Subject: Military Cutoff Road (SR 1409) from just North of US 74
(Eastwood Road) to Market Street. State Project No.
8.2251001, Federal Project No. NHF-1409; TIP U-2734.

STORMWATER MANAGEMENT PERMIT APPLICATION FORM
NORTH CAROLINA DEPARTMENT OF TRANSPORTATION
LINEAR ROADWAY PROJECT

Subject: Minutes from Interagency Hydraulic Design Review Meeting on March 28, 2002 for U-2734 (Military Cutoff Road Widening), New Hanover County

Subject: Draft Minutes from Interagency Permit Review Meeting
on February 20, 2003 for U-2734 in New Hanover County

DETAILS OF NATURAL STREAM DESIGN FROM STA 21+46 TO -L- STA 22+07 -L- (RT) & FROM STA 22+80 TO STA 23+44 -L- (RT)

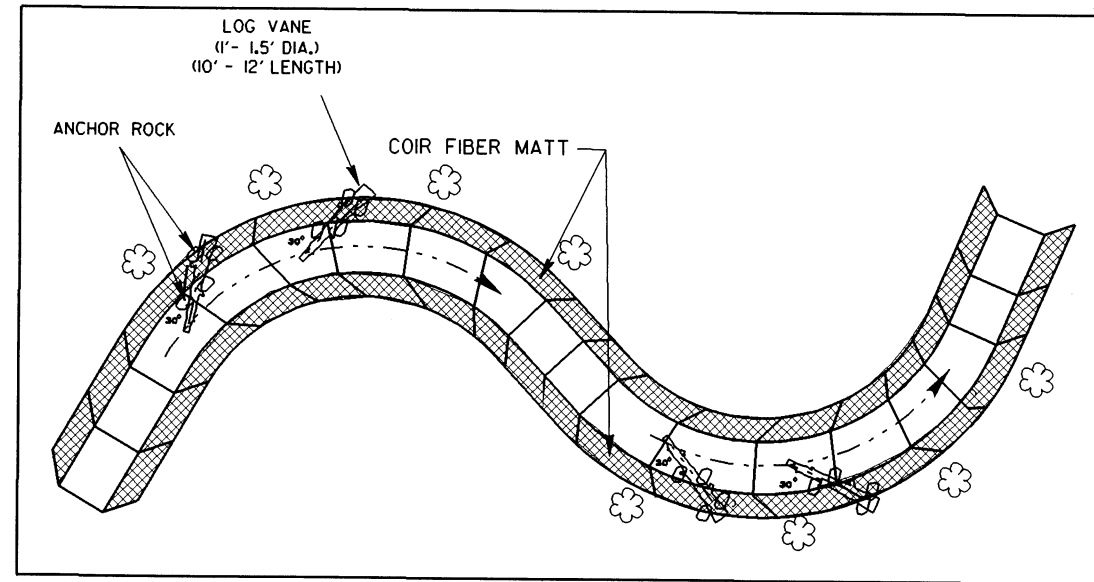
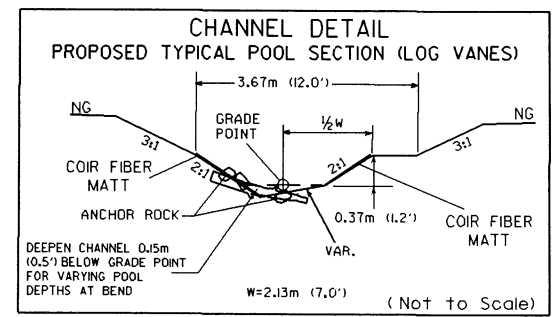
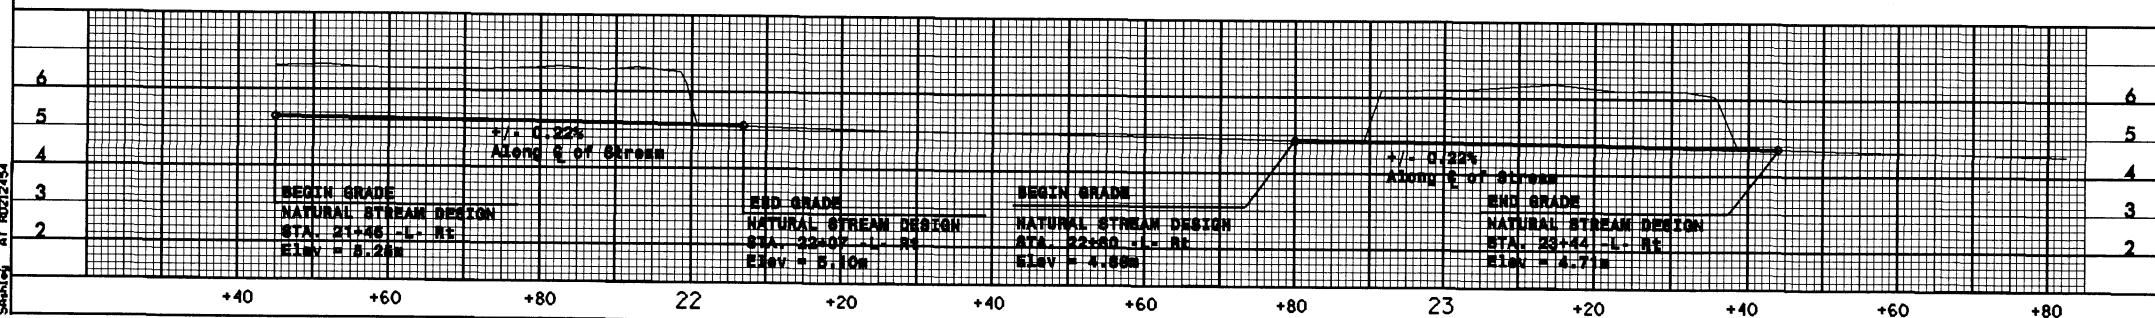
- Review the natural stream design data (Site 1) and investigate whether more stream could be designed for additional mitigation credit. Dave will present any

specific questions/comments once he reviews the stream site in the field. Also, check the impact summary sheet. Stream impact length looks suspect and the length of "Relocated Channel" was not accounted for. Galen will review and make necessary changes.

It was discussed that Dave Timpy requested, after reviewing in the field with Galen, to revise the stream relocation by retaining the existing remnant stream and providing relocation in only the areas that are being filled. He also requested providing more stream relocation than is presently being proposed by starting further Southeast. John thought this was a good idea but to investigate improving the remnant stream dimension, since Galen suggested it was entrenched. Also, need to provide existing and proposed stream profile. Galen will update morphological data and review with John at a later time.

Stream relocation revised per Dave Timpy's recommendations. See "Natural Stream Design" summary.

RIGHT OF WAY REVISION 07/16/03 REVISED NATURAL STREAM DESIGN

**** HAZARDOUS SPILL RETENTION BASIN**
SEE STD. #838.02

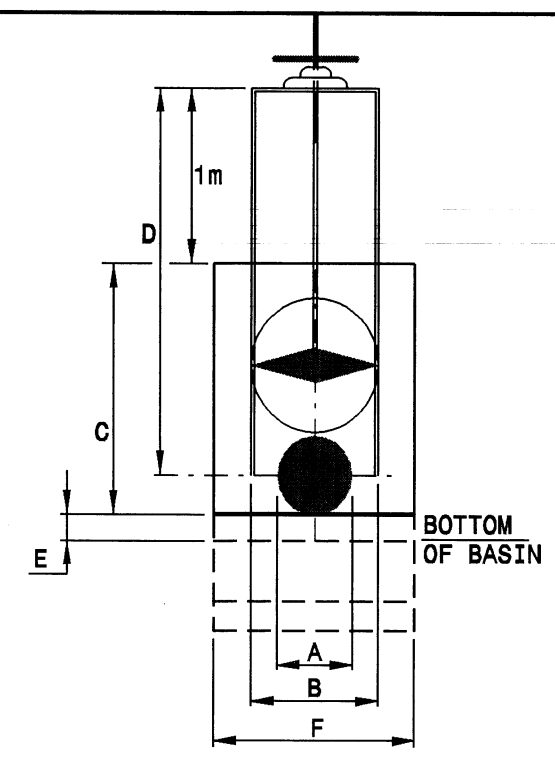
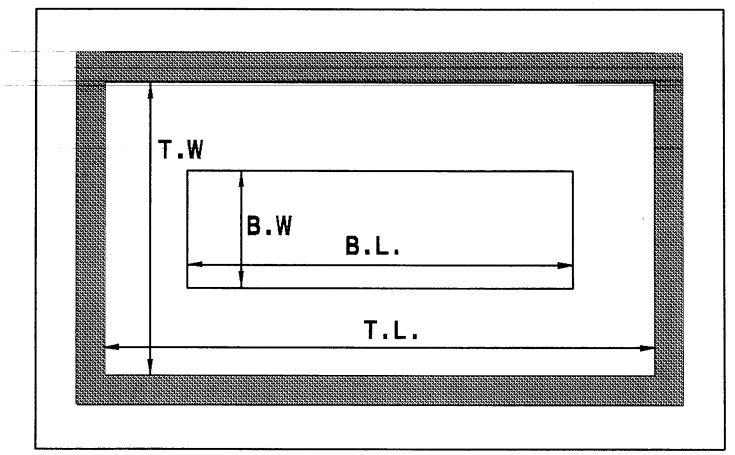
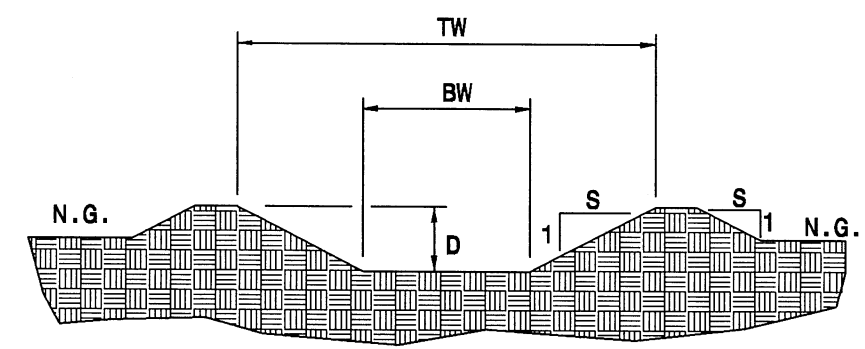
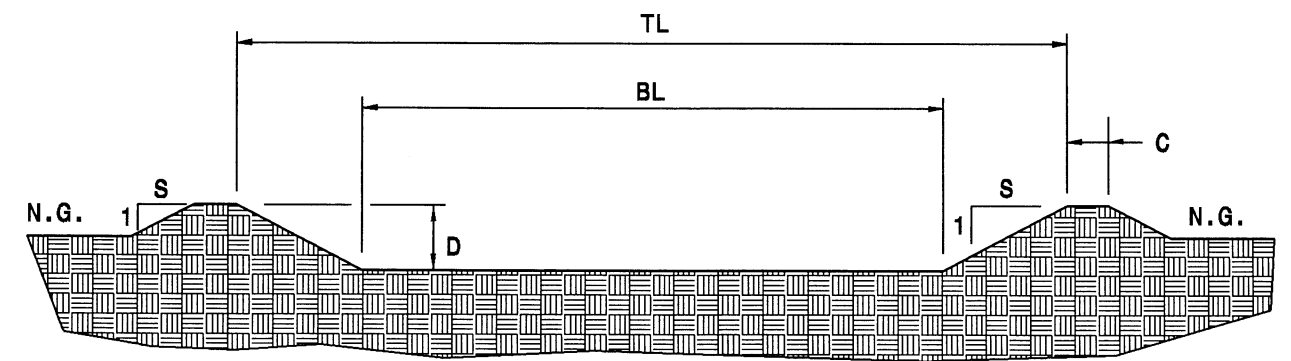
- 1) Wetland and Stream Impacts at Howe Creek: The wetland limits at Howe Creek need be reinvestigated. Additional delineation may be required to determine which side is more suitable for hazardous spill basins (East or West side of Military Cutoff Road). Lindsey Riddick will check delineation. It was also questioned whether stormwater could even outlet in the wetlands or within 575' on each side of Howe Creek since it is considered an Outstanding Resource Water and falls under CAMA jurisdiction. Cathy Brittingham investigated and informed that, since no CAMA permit is required for this section of Howe Creek (non-navigatable) and it is not an AEC, stormwater can outlet within the 575' buffer and in the wetlands. However, velocities must be non-erosive.

- 2) Hazardous Spill Basins at Howe Creek: Dave Timpy emphasized the importance of constructing the basins on the side which will result in the least impact to the wetlands. John Hennessey wanted to know what treatment is provided since the hazardous spill basin is not a treatment facility. He was informed that treatment is acquired as stormwater traverses to the basins through grassed swales and also through storage provided by raised grated inlets (6" at each inlet) in the swales. John also emphasized that outlet velocities into the Howe Creek basin need to be non-erosive and flow spreaders should be considered. Also the basins, as designed, need to be relocated out of the wetlands.

It was determined to keep the proposed hazardous spill basins on the east side of Military Cutoff based on the following:

- The extent of the wetland boundaries are comparable on either side of the road*
- The basins will not impact the wetlands except for the minimal ditching required to enable the basin riser pipe to outlet*
- The future Mayfaire development has proposed detention in the Southwest quadrant of the crossing*
- The east side of Military Cutoff is the downstream side of the crossing and thus the discharge in the basins will not have to pass back through the proposed box culvert.*

5 0 10 CONST. REV. R/W REV. 07/16/03	PROJECT REFERENCE NO. U-2734	SHEET NO. 6
	R/W SHEET NO. 6	HYDRAULICS ENGINEER
ROADWAY DESIGN ENGINEER		PRELIMINARY PLANS <small>(DO NOT USE FOR CONSTRUCTION)</small>

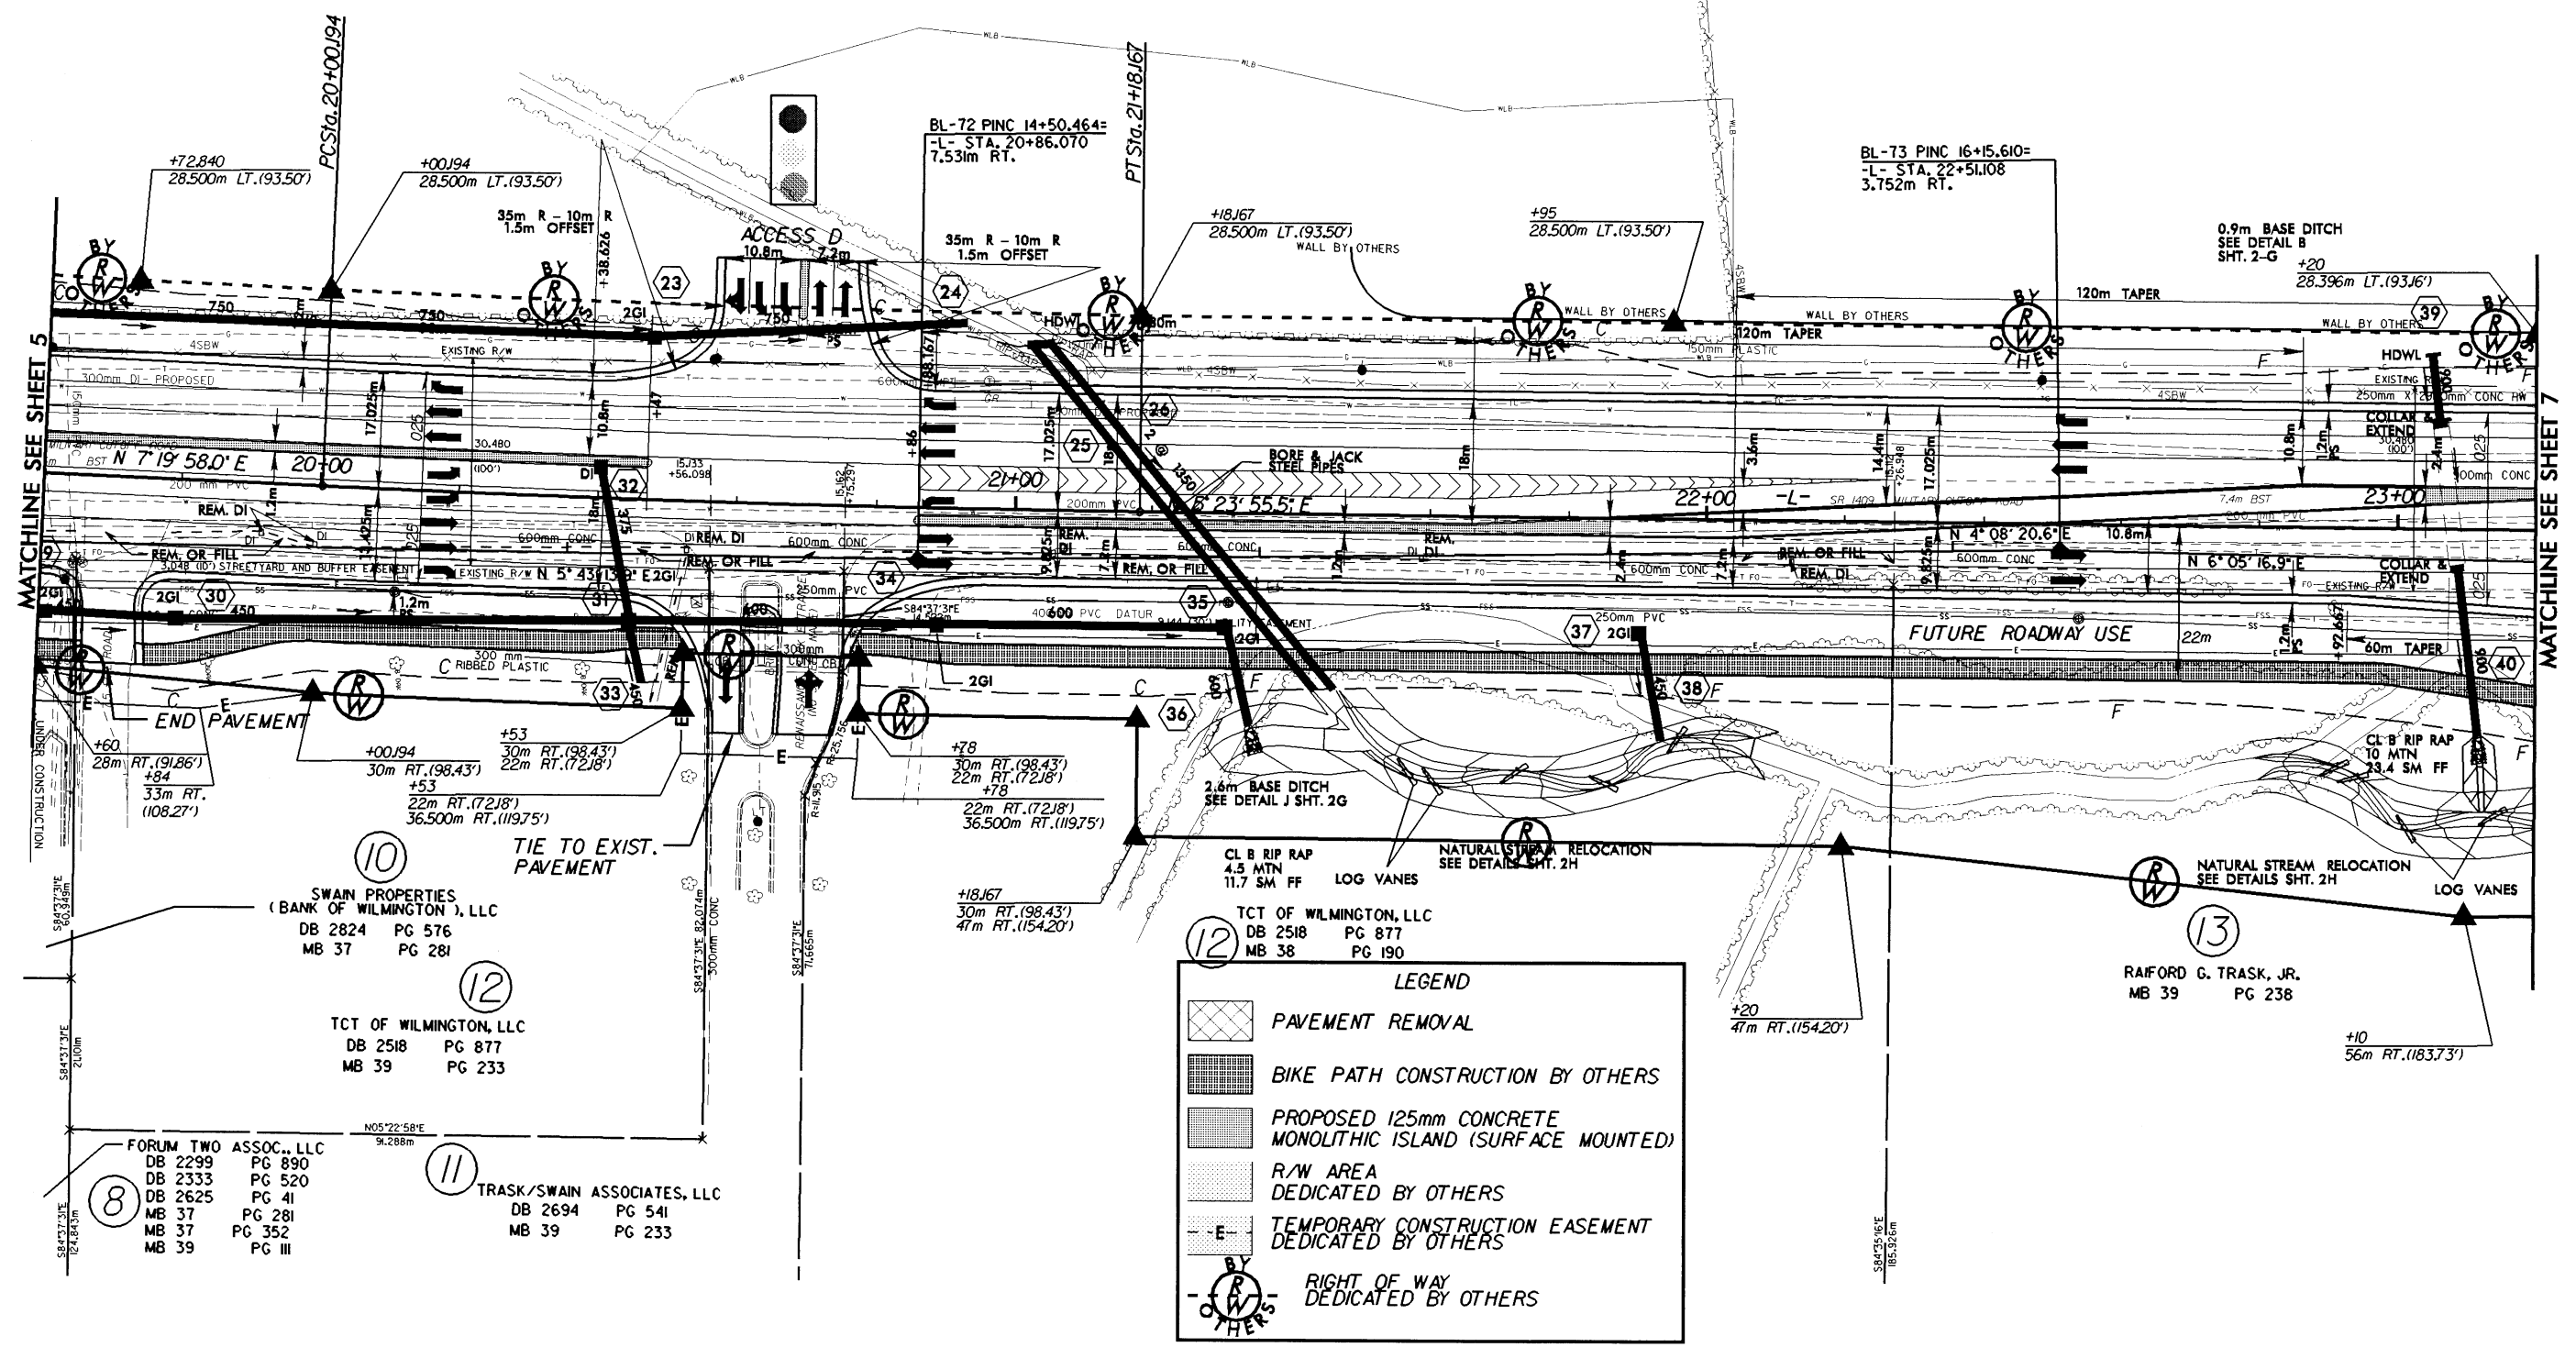
RIGHT OF WAY REVISION 07/16/03: REVISED
RIGHT OF WAY FROM STA. -L- 21+18+/- TO -L- STA. 22+20+/- - RT.

PROJECT REFERENCE NO. U-2734
SHEET NO. 8

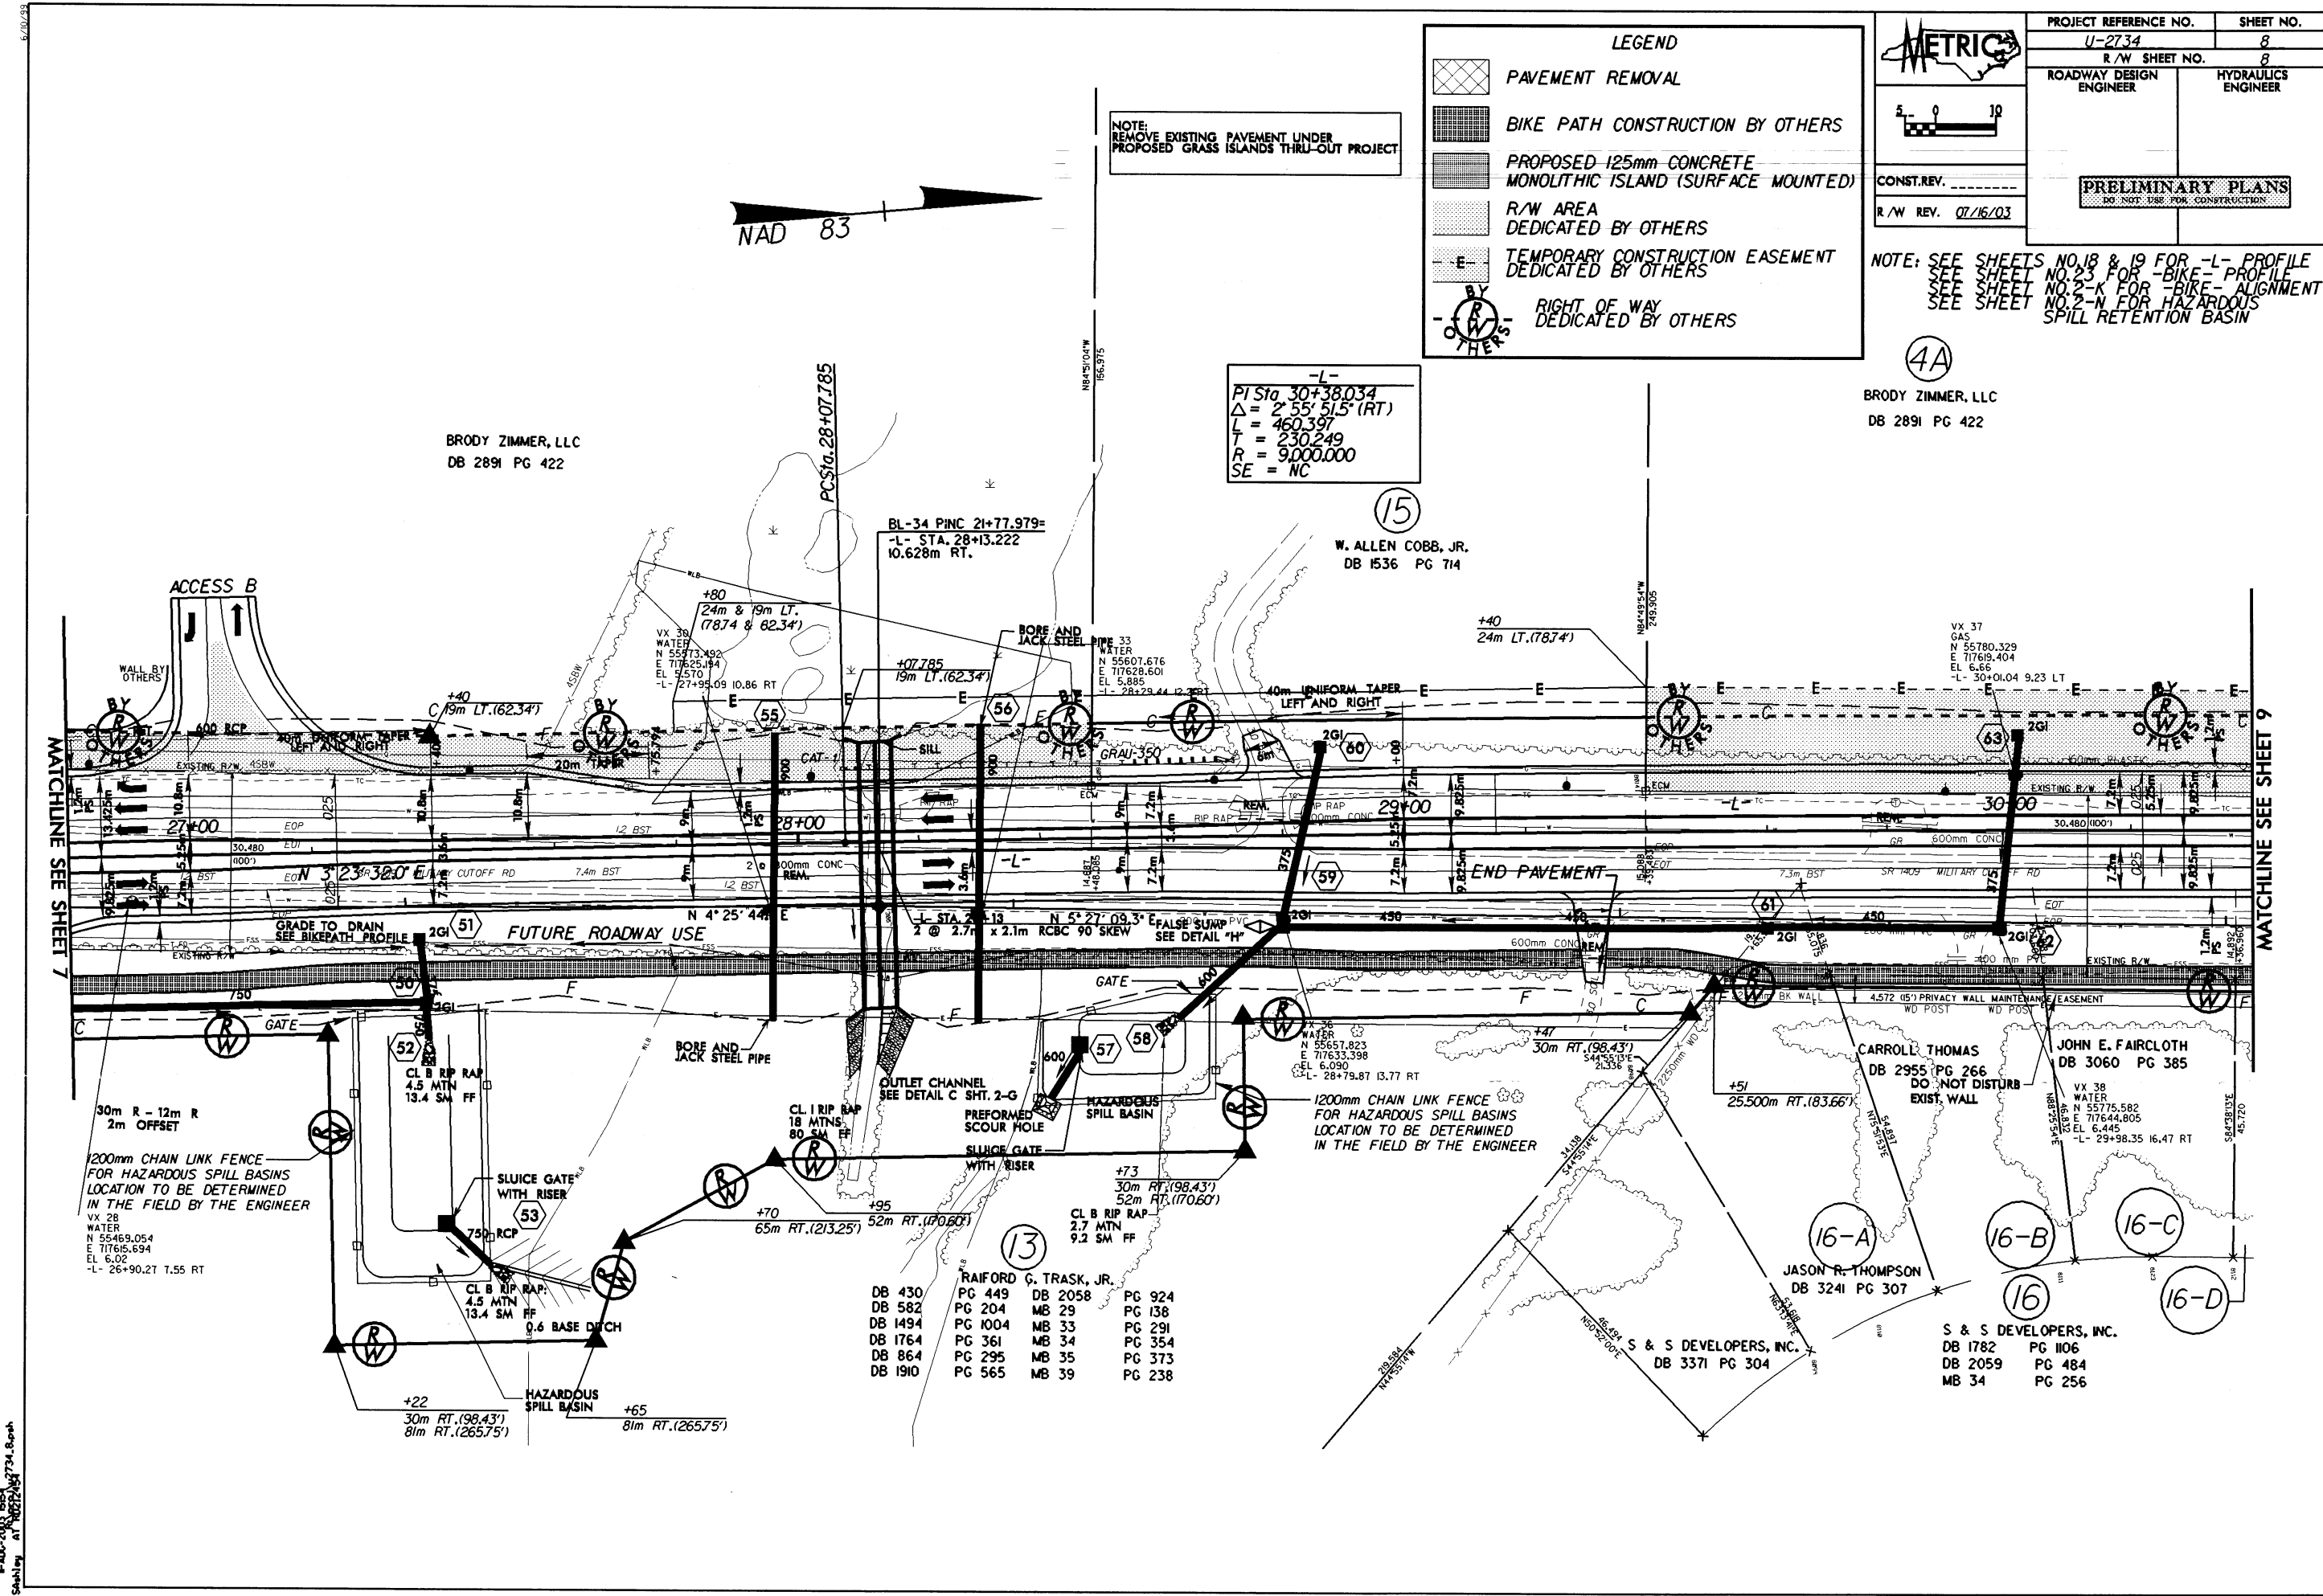
RIGHT OF WAY REVISION 7/16/03
EXTENDED TCE FROM 29+40 TO 27+80 LT.
